Production: **Airmate-USB Triple input module**

Modification to reduce a second start pulse caused by variations in component values

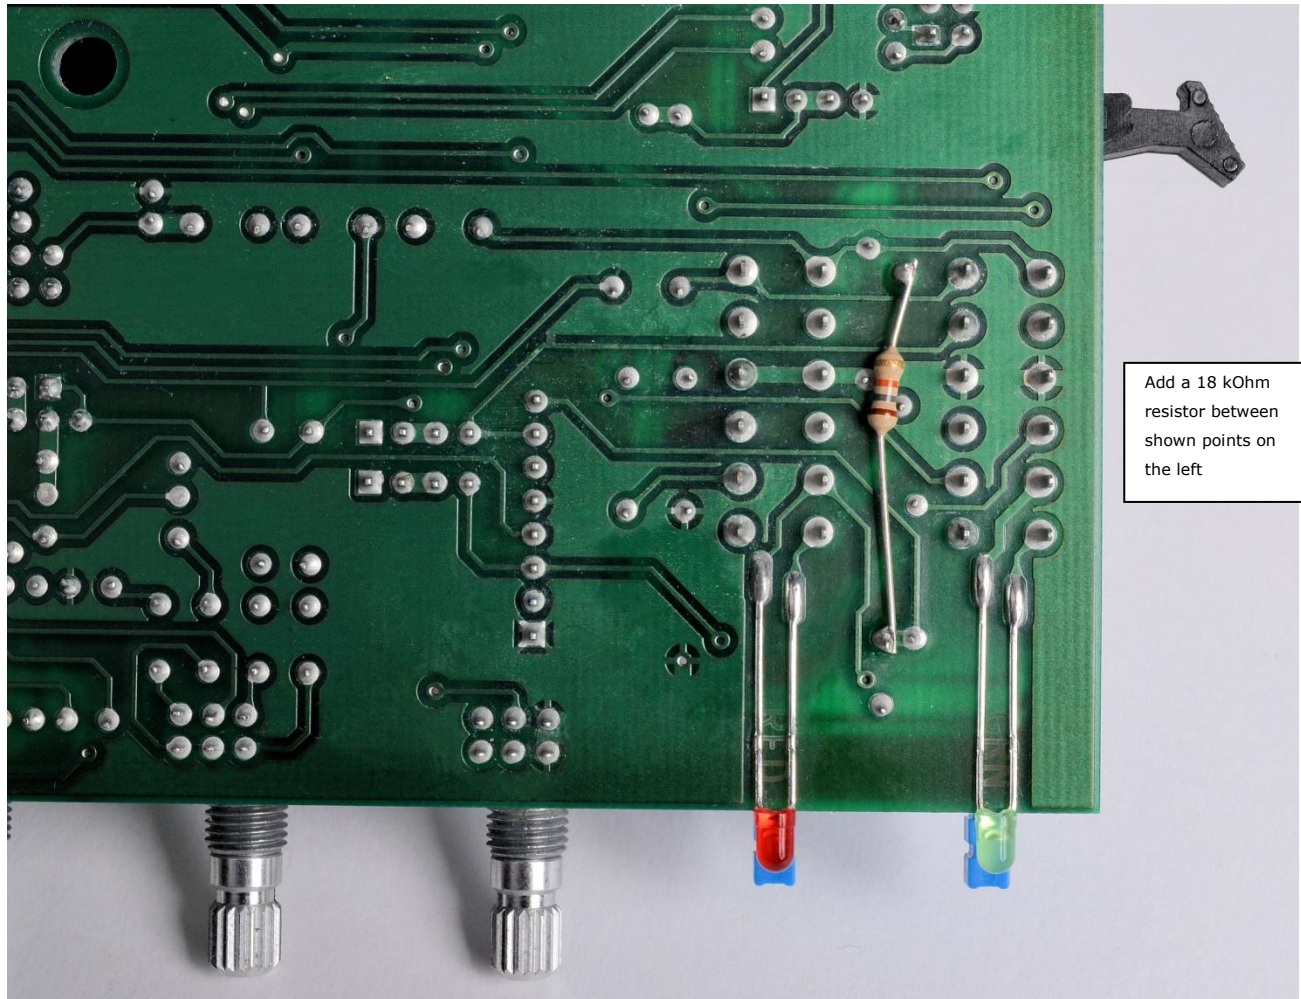
1. This modification can be performed without taking out the whole module, but this is a precise job to do. But... saves a lot of time.

If you cannot reach the lower solder point where the extra 18kOhm resistors needs to be soldered to, then the only solution is take out the complete module(s).
